### STAFF RECOMMENDATION 2534 Blair Boulevard March 15, 2017

**Application:** New construction – addition; Partial demolition  
**District:** Hillsboro-West End Neighborhood Conservation Zoning Overlay  
**Council District:** 18  
**Map and Parcel Number:** 10411030000  
**Applicant:** Rachel Martin  
**Project Lead:** Melissa Sajid, melissa.sajid@nashville.gov

**Description of Project:** The application is to demolish a partially covered deck and to construct a three hundred and eighty-four square feet (384 sq. ft.) screened porch addition.

Figure 1: 2534 Blair Boulevard

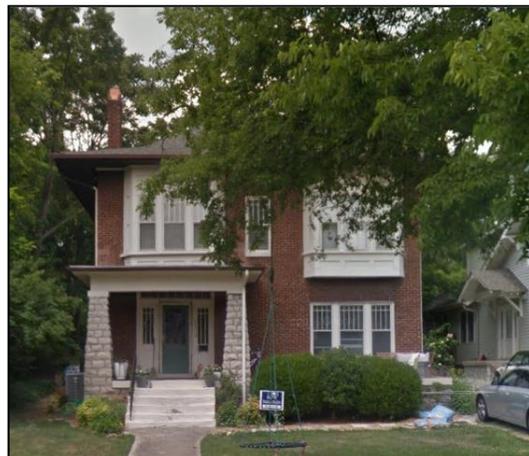
**Background:** The house located at 2534 Blair Boulevard was built c. 1930 (Figure 1) and contributes to the historic character of the Hillsboro – West End neighborhood.

Figure 3: 1931 Sanborn map

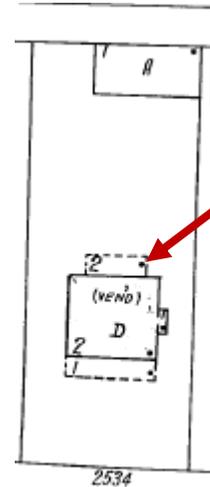
**Partial Demolition:** The application proposes to demolish a partially covered rear deck (Figure 2). The 1931 Sanborn map indicates shows a rear covered porch that does not extend the full width of the rear

of the building (Figure 3). The existing covered porch has since been enclosed and expanded nearly the full width of the building. Staff finds that the proposed demolition of the covered deck is appropriate as the porch is located at the rear of the house, has been significantly altered, and is not a character defining feature of the historic house.

Staff, therefore, finds that the proposed partial demolition meets Section III.B.2 for appropriate demolition and does not meet section III.B.1 for inappropriate demolition.
